# Marion St. Bridge

This was the Seattle Design Commission's (SDC) third review of the Marion Street Bridge project. The purpose of this meeting was to review the design development (90% design phase) for the project. After the presentation and discussion, the SDC voted 8-1 to approve the design development phase with several recommendations.

90% - Design Development

Figure 1 Plan and section of proposed bridge design

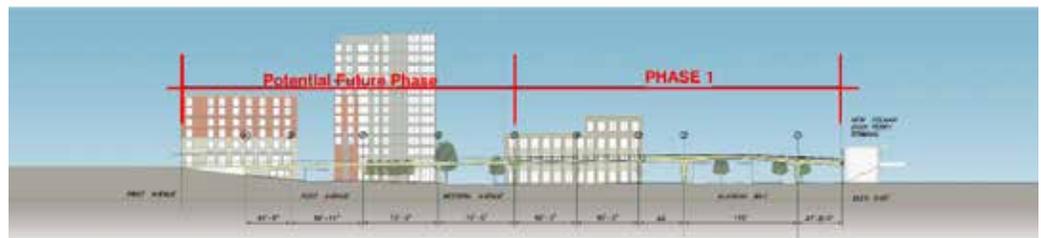
The SDC commended the project team for their responsiveness to previous design issues related to lighting, column shape, and handrail details. The commission expressed concern with the east and west transition points, including the lack of details describing the materials and function of the transition points at the east and west end of the pedestrian bridge. The Commission strongly recommended the project team provide more details about the proposed materials and function of both transition points. The Commission also expressed concern with the proposed transition between the bridge and Colman Dock. Commissioners agreed the current proposal for the design of the transition was not adequate in providing a sense of arrival for pedestrians using the bridge to access Colman Dock. The SDC then recommended the project team continue to work with Colman Dock to create a partnership so the ferry terminal can serve as a point of arrival for pedestrians using the bridge.

The SDC then expressed concern over the current proposal for drainage and water management. Although commissioners understand the project team's desire to create bridge elements that were as elegant as possible, they strongly recommended project team think of creative solutions to solve issues related to the location of drainage. Specifically commissioners recommended the project team consider the integration of drainage within the columns, so that the appearance of any drainage features are well integrated with the building concept and design details.

The SDC then discussed issues around future phasing, funding, and temporary transitions. The Commission continued to raise concerns over constructing the project in two phases. Commissioners are concerned that if the full project is not constructed at one time, then the future phase might not be constructed. The SDC strongly recommended the project team provide clarification regarding timing of funding for the future phase. The Commission also recommended the project team continue to explore funding opportunities to build the project in one phase.

1. Continue to think about proposed materials and overall function of transition at the east and west end of the bridge
2. Continue to work with Colman Dock to create a partnership so they can be a point of arrival and receiving partner for the pedestrians using the pedestrian bridge

3. Think creatively to solve issues related to the location of drainage elements on west end of the pedestrian bridge, including the potential for integration of drain into column

Figure 2: proposed design of temporary transition (top), updates to the proposed lighting scheme (bottom)

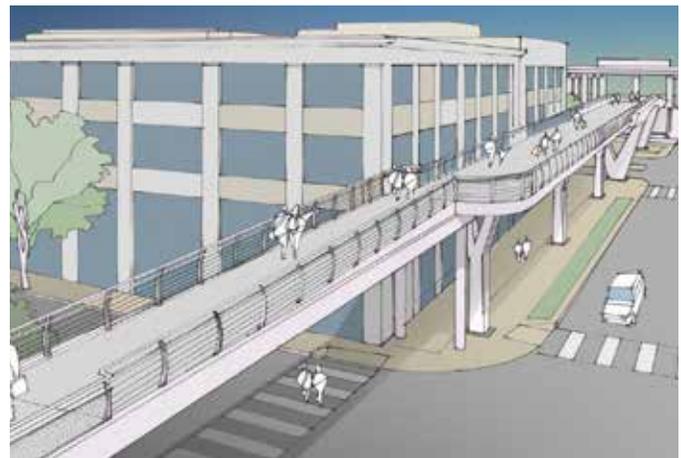
The Commission commended the project team for responding to previous concerns related to the design of the transition between the proposed bridge and existing pedestrian pathway. Specifically, commissioners agreed with the proposed curve guardrail design at the location where Phase 1 will terminate at Western Avenue. Several commissioners are worried that the curved railing might imply that this is a permanent transition, while other commissioners questioned why so much time and funding was being allocated to a temporary section. The SDC then recommended the project team reuse the guardrail elements along the temporary guardrail for the future phase.

The SDC appreciated the overall direction of the proposed design and location of lighting elements as well as the proposed lighting program (the use and timing of color changing fixtures). Commissioners appreciated that the project team was consulting with a lighting designer and suggested the team utilize the color changing lighting option only during appropriate events throughout the year. The commission then recommended the project team explore the newest technology for pedestrian lights, specifically as it relates to including warmer white lights and RGB-W fixtures.

4. Provide clarification of timing of funding for future phase and continue to explore funding opportunities to build the project in one phase
5. Explore reusing guardrail elements in temporary walkway for future phase

6. Explore providing an opportunity for art at both transition points if transition cannot match materials used on the connecting facilities
7. Explore newest technology for pedestrian lights, specifically to include warmer white light
